**STAKER FARMSTEAD ESTATES
RESIDENTIAL CLUSTER SUBDIVISION
NE 1/4 SECTION 33 TOWNSHIP 6 NORTH RANGE 2 WEST SLB&M**

**PRELIMINARY PLAN SUBMITTAL-STREET, COMMON AREA, AND STREET LIGHT SECTIONS/DETAILS
18 LOT RESIDENTIAL CLUSTER SUBDIVISION WEBER COUNTY, UTAH**

PROJECT MEMORANDUM

Subject: Staker Farmstead Estates-Resubmittal of Preliminary Plan

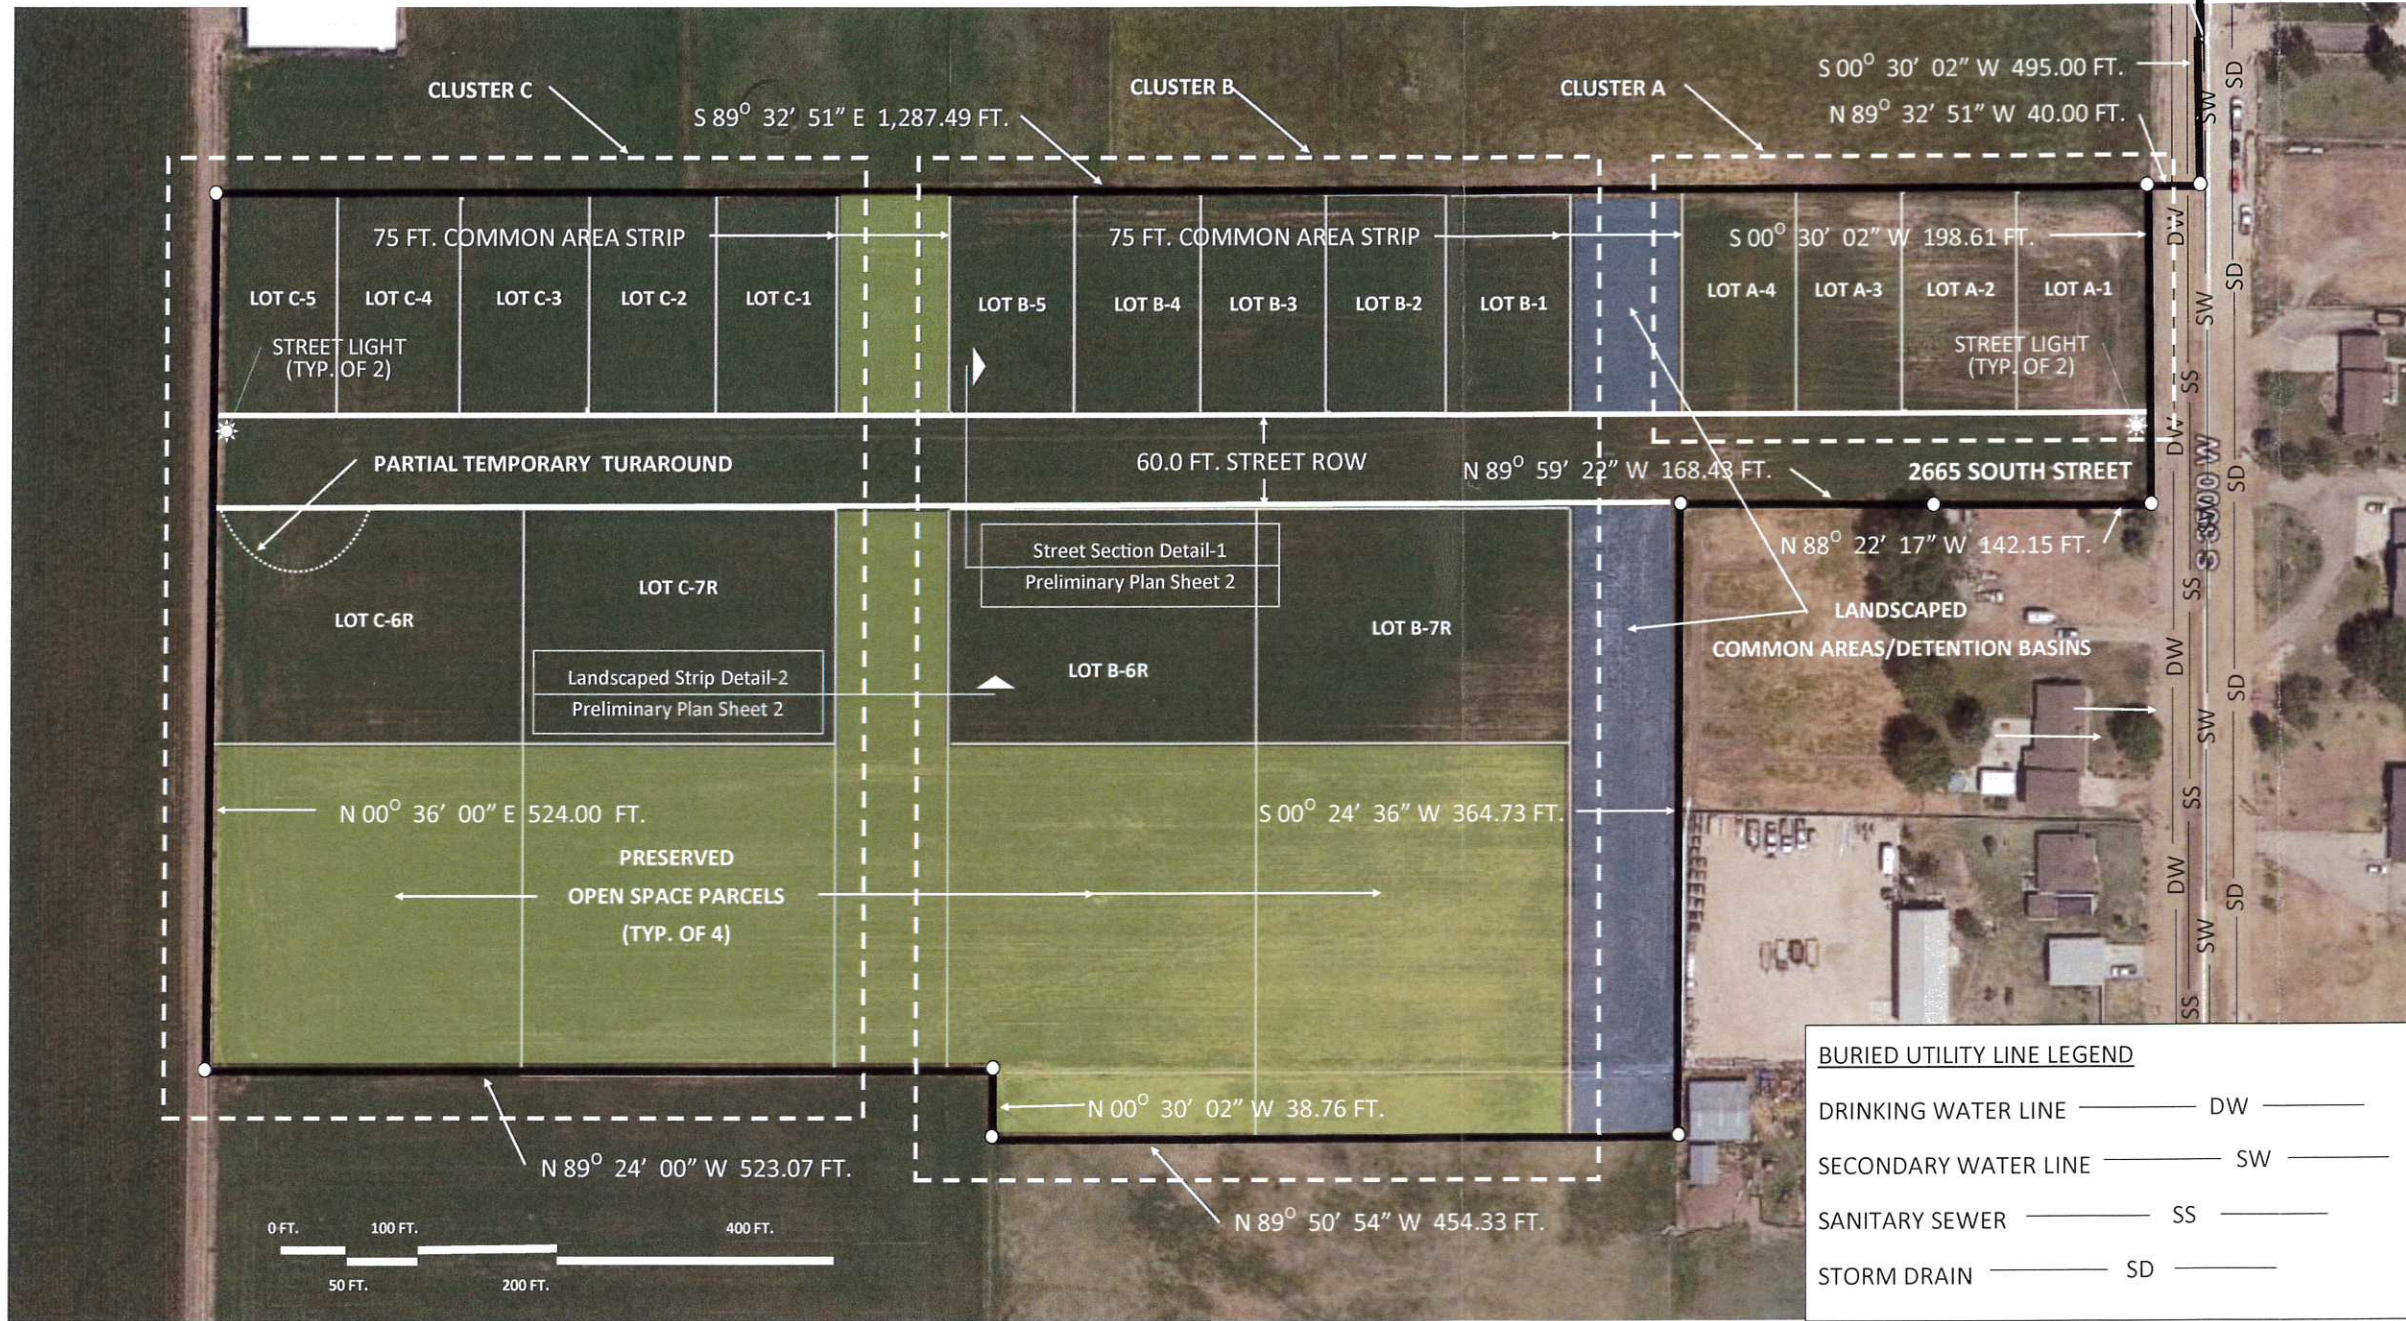
I am assuming the single pole without a cantilevered arm option is acceptable for the Staker Farmstead Estates subdivision. I've shown two street lights within my proposed subdivision's street public right-of-way and a typical cross section showing the typical location of a proposed street light within the required street grass strip on sheets 1 of 2 and 2 of 2 respectively as shown on the revised Preliminary Plans.
